1  
2  
3  
4 **BEFORE THE HEARING EXAMINER OF THE CITY OF MERCER ISLAND**

10 APPELLANT DANIEL GROVE'S  
11 NOTICE OF APPEAL OF BUILDING  
12 PERMIT NO. 2207-019

16 This is an action to stop an illegal construction project that grossly violates the Mercer  
17 Island City Code. Building Permit 2207-019 ("Permit 2207-019") proposes to demolish an existing  
18 house and build a new, larger home along with accessory structures at 6950 SE Maker Street on  
19 Mercer Island, Washington. On February 20, 2024, the City of Mercer Island ("City") approved  
20 Permit 2207-019 despite considerable evidence demonstrating that the proposal fails to comply  
21 with existing rules and regulations. The City's approval is in substantial error and is unsupported  
22 by the evidence in the record.

**Figure 2: Final Plan Set with Existing Grade Overlay**

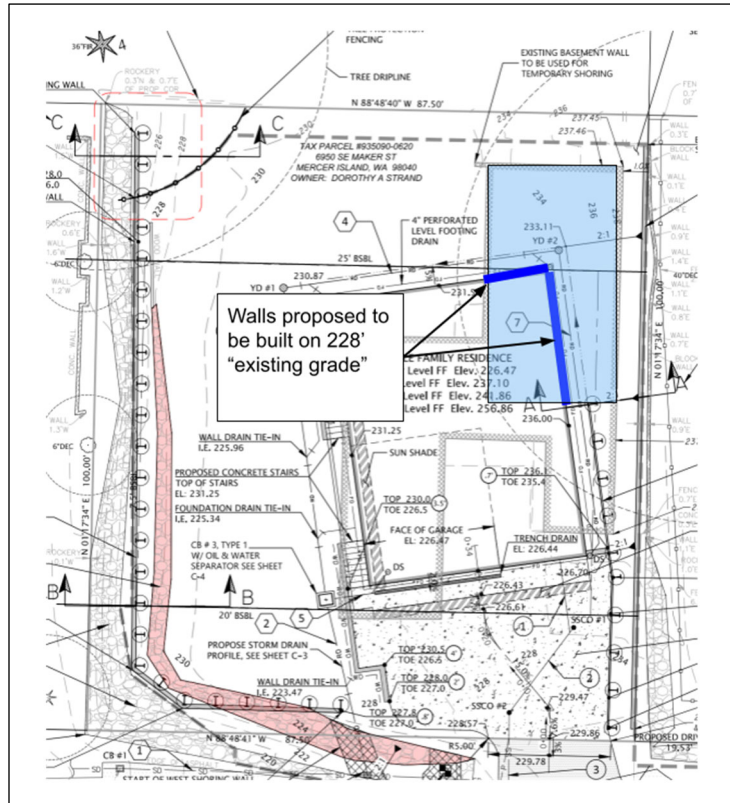
1 existing structure is built with slabs directly on dirt. *See* Exhibit F (Construction Photos).  
2 Therefore, the elevation of “existing grade underlying the existing structure” is the elevation of  
3 that dirt underneath the existing structure. *See* Administrative Interpretation 12-004. Despite this,  
4 the City has permitted the Applicant to interpolate the grades within the footprint of the existing  
5 structure, contrary to the Administrative Interpretations and its own previous determinations. The  
6 City’s expert, Mr. Harper, specifically stated that: the existing surveys<sup>6</sup> “do not serve as a  
7 “snapshot” of original grade conditions and cannot be relied on for interpolation or other such  
8 formulaic determinations of *any past original grade.*” Exhibit G at 1 (emphasis in original).  
9 Evidence in the record shows that the existing grade underlying the northeast portion of the

10 structure is 3 feet to 7 feet lower than the existing grade shown in the plans. This evidence includes  
11 photographic evidence of the existing structure (both when it was under construction, and as it  
12 exists today), and the elevation measured by the Applicant’s at the northwest entrance to the  
13 existing structure. Exhibit D (Final Plan Set); Exhibit F (Construction Photos). For example,  
14 photographic evidence comparing grades west of existing house during its 1950s construction  
15 show the entire site has been significantly altered over time, both in the yard and underneath the  
16 existing structure. *See* Exhibit F (Construction Photos).

17 Use of the higher than permitted existing grade improperly increases several metrics,  
18 including the wall segment coverage and basement exclusion area, both of which are used in  
19 calculating the gross floor area to determine the resulting size of the home. It also skews the  
20 “average building elevation” calculation.<sup>7</sup> Because the midpoint of the proposed house’s eastern  
21 wall lies within the existing house, its elevation is the elevation of the grade underlying the existing  
22 structure at that point. The elevation of this midpoint should also be determined per Administrative  
23 Interpretation 04-04 in order to correctly compute “average building elevation” and “maximum

- a) As to the existing and finished grade error, the Hearing Examiner should remand to the City to require (i) the Applicant to fully complete the record by demonstrating the grade underlying the existing house, (ii) correctly determine existing grade, and (iii) correctly determine finished grade;

**Figure 3: Comparison 7'5" proposed (yellow) and 10' (red) east side yard**

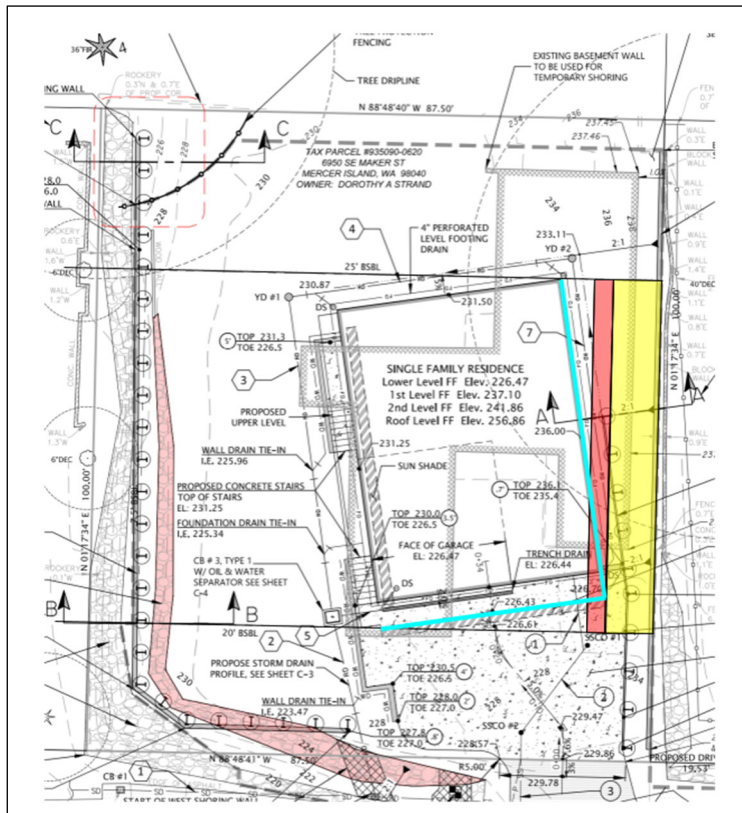
11 In Mercer Island, single-family dwellings with a height of more than 25 feet measured from  
12 the existing or finished grade, whichever is lower, to the top of the exterior wall facade adjoining  
13 the side yard must provide a minimum side yard depth of **ten feet**. MICC 19.02.020.C.1.c.iii.b.  
14 (emphasis added).<sup>8</sup> This allows sufficient space between homes or structures and reduced  
15 crowding. But, here, the side yard is only 7.5 feet. The City appears to have allowed this because  
16 *part* of the façade adjoining the side yard is less than 25 feet while other portions are demonstrably  
17 over 25 feet. *See* Exhibit D (Final Plan Set) at A1.0 and A3.1. Specifically, the relevant portion of  
18 the façade is on average 28' in height while the highest point is 33.9' per the Final Plan Set. The  
19 Applicant cannot cherry pick a shorter section to avoid this requirement.<sup>9</sup> The City erroneously

21 **Figure 3** below depicts the impact of a 7.5 foot versus 10 foot side yard on the surrounding  
22 areas. Figure 3 is derived from the Final Plan Set with an overlay. This shows how much closer  
23 Ms. Strand's proposed home will be to Mr. Grove's than it is otherwise allowed.

24 <sup>8</sup> Because there is a facade with a height of more than 25 feet adjoining the Applicant's east "side yard," MICC  
19.02.020(C)(1)(c)(iii)(b) mandates that the required east "side yard" depth be 10 feet.

25 <sup>9</sup> The Applicant appears to have misunderstood this portion of the code as Sheet A1.0 contains a note pointing to the  
26 east side of the proposed house as "10'-0" SETBACK ABOVE 15'." While the code actually states: "Single-family  
dwellings with a height of more than 25 feet measured from the existing or finished grade, whichever is lower, to the  
*top of the exterior wall facade adjoining the side yard* shall provide a minimum side yard depth of ten feet." MICC  
19.02.020.C.1.c.iii.b. (emphasis added).

- c) As to the required side yard errors, the Hearing Examiner should remand to the City to require the applicant to increase the depth of the east “required side yard” to the 10 feet required by the code;

13 **Figure 4: Distance from rooftop railing to finished grade**

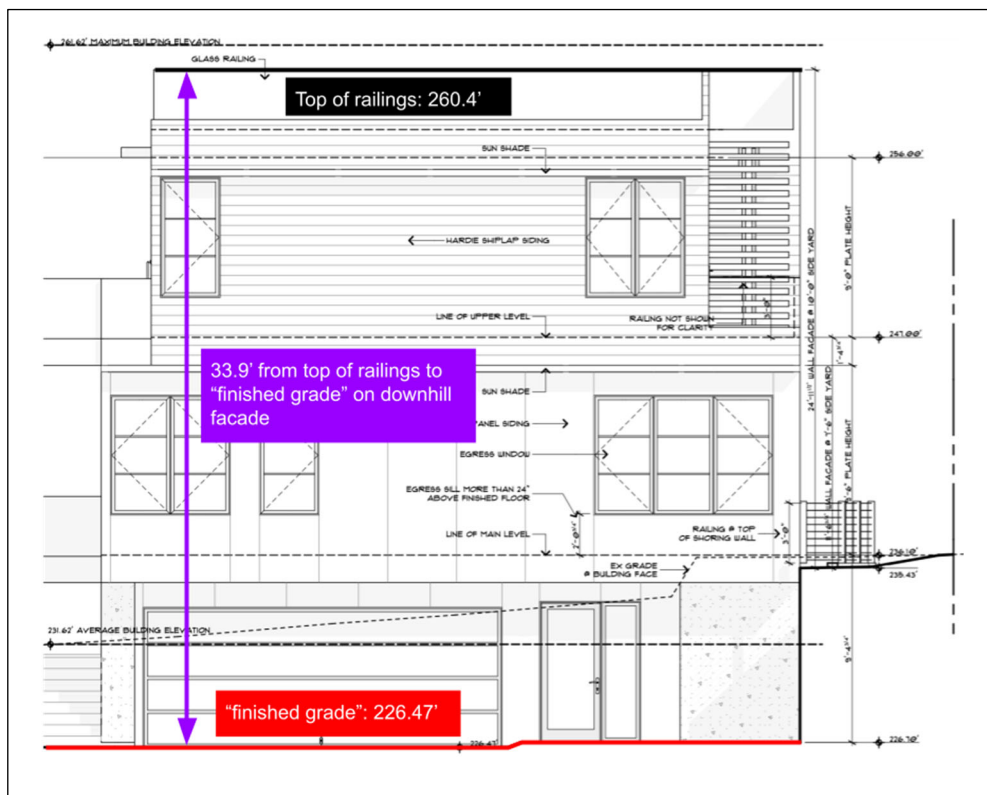
The City erroneously approved design plans that exceed the maximum building height limit by almost four feet when measured on the downhill side of the sloping lot. In most cases, maximum building height cannot exceed 30 feet above the average building elevation. MICC 19.02.020.E.1. For downhill sloping lots, like this one, the maximum building facade height also cannot exceed 30 feet in height. MICC 19.02.020.E.2. Building facade height, which includes the rooftop railings,<sup>10</sup> is “measured from the existing grade or finished grade, whichever is lower, at the furthest downhill extent of the proposed building, to the top of the exterior wall facade.” *Id.* The height limit can be increased up to five feet for certain appurtenances like chimneys or solar panels. MICC 19.02.020.E.3. But, the code expressly excludes rooftop railings from that list of allowable

1 appurtenances by stating “rooftop railings may not extend above the maximum allowed height for  
2 the main structure.” MICC 19.02.020.E.3.b.

3 The property at issue in this case slopes downhill primarily from east to west. The rooftop  
4 railings attached to the southern exterior wall and the southern end of the western wall both exceed  
5 maximum allowed heights. Those railings may not extend more than 30’ above the lower of the  
6 “finished grade” or “existing grade” at the furthest downhill extent of the proposed house. The  
7 finished grade at the furthest downhill extent of the façade on the southern end of the house is  
8 226.5’, the railings are at 260.4’, exceeding the maximum height allowed by at least 3.9 feet. The  
9 City has provided no information regarding why these rooftop railings should be exempted from  
10 existing regulations. Figure 4, below derived from Sheet A3.1 \_\_\_ of the Final Plan Set shows (in  
11 black) the rooftop railings that extend above 256.5’ at the furthest downhill extent of the proposed

- d) As to the rooftop railing errors, the Hearing Examiner should remand to the City to require the proposal be brought into compliance with existing height restrictions; and
